Design Review Subcommittee (DRSC)

Meeting Date: August 12, 2015

SUBJECT: CUP 15-211/MCHP 15-212, Shwack Cantina, a request to consider on-site consumption of a full range of alcoholic beverages, and a façade remodel for a commercial restaurant building. The project is located at 1527 N. El Camino Real and is in the Mixed Use land use designation, and the Pedestrian, Architectural, and Coastal Zone Overlays (MU3-P-A-CZ), and is located adjacent to a historic structure.

Exhibit 1- Awning Examples

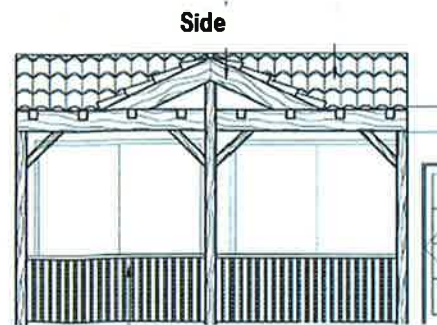
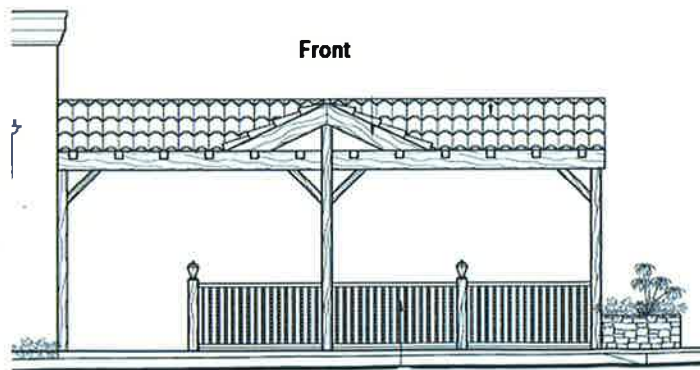
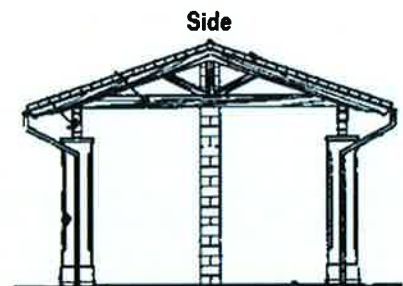
1. **Front Elevation- Window Trellis.** The window trellis detail as designed is typical of traditional, cottage or craftsman style architecture. Staff recommends a more Spanish Colonial Revival window treatment, such as cloth awnings with wrought iron spires. The awnings could add color and potentially a place for small scale signs. Exhibit 1 shows examples of the recommended awnings.

Exhibit 2- Proposed and Traditional Pergola Detail

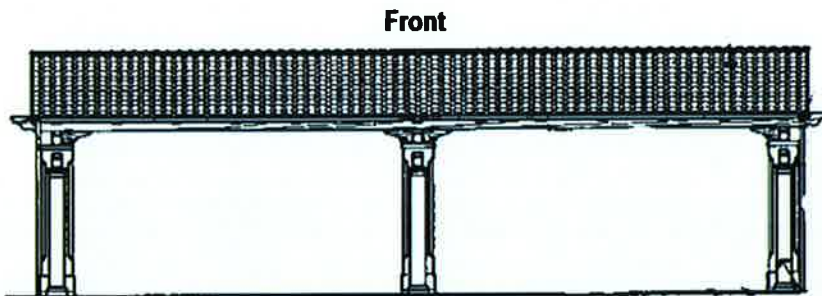
- 2. **Front Elevation- Pergola.** The proposed pergola gable elements should be simplified to be consistent with traditional design. Staff recommends modifying the structure to a single ridge. See Exhibit 2 below for an example.
